When GATE MPCPDU with (force\_report == 0) has come,  
how ONU should do?

# Proposal : Add some comments when ONU don't send anymore

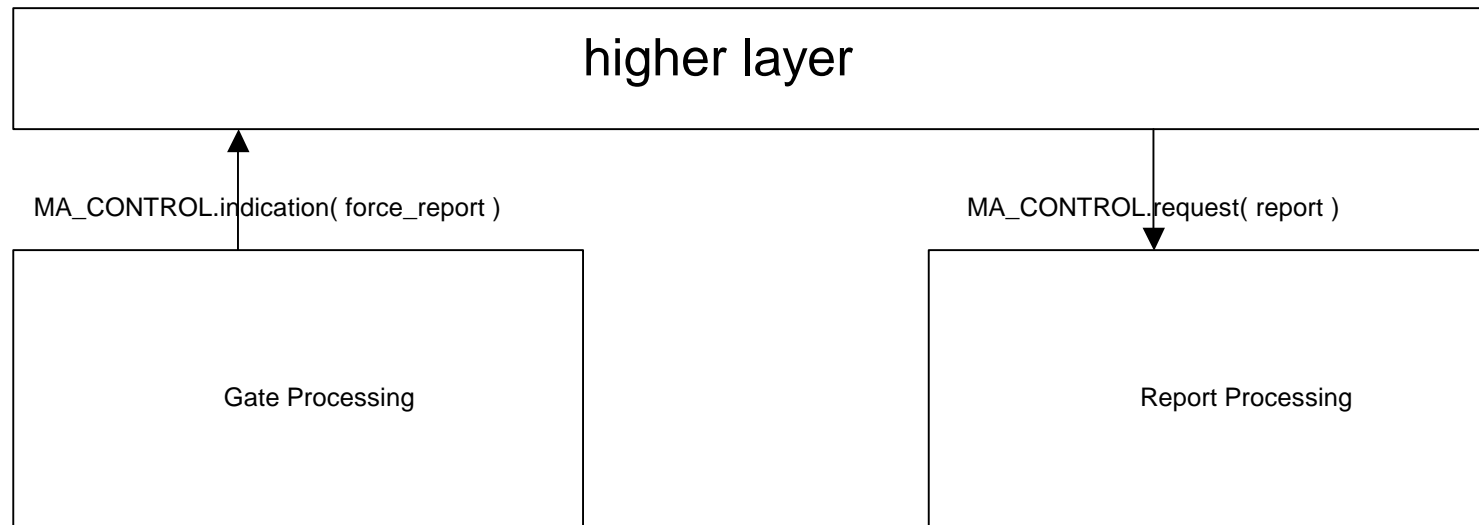
```
(a) If ( force_report == 1),
    if ( some data in the buffer of the ONU ) then
        ONU should send a REPORT MPCUDU properly.
    else
        ONU should send a REPORT MPCUDU with empty content.
    endif

(b) If ( force_report == 0)
    ONU may send a REPORT MPCPDU whether there are some data or not.
```

When ONU don't send any data or MPCPDU, ONU should send IDLE symbol pairs.

( I feel that "higher layer" will achive these behaviors in the box of the broken line.)

( I feel that "MPCP layer" should achive this behaviors out of the box of the broken line.)
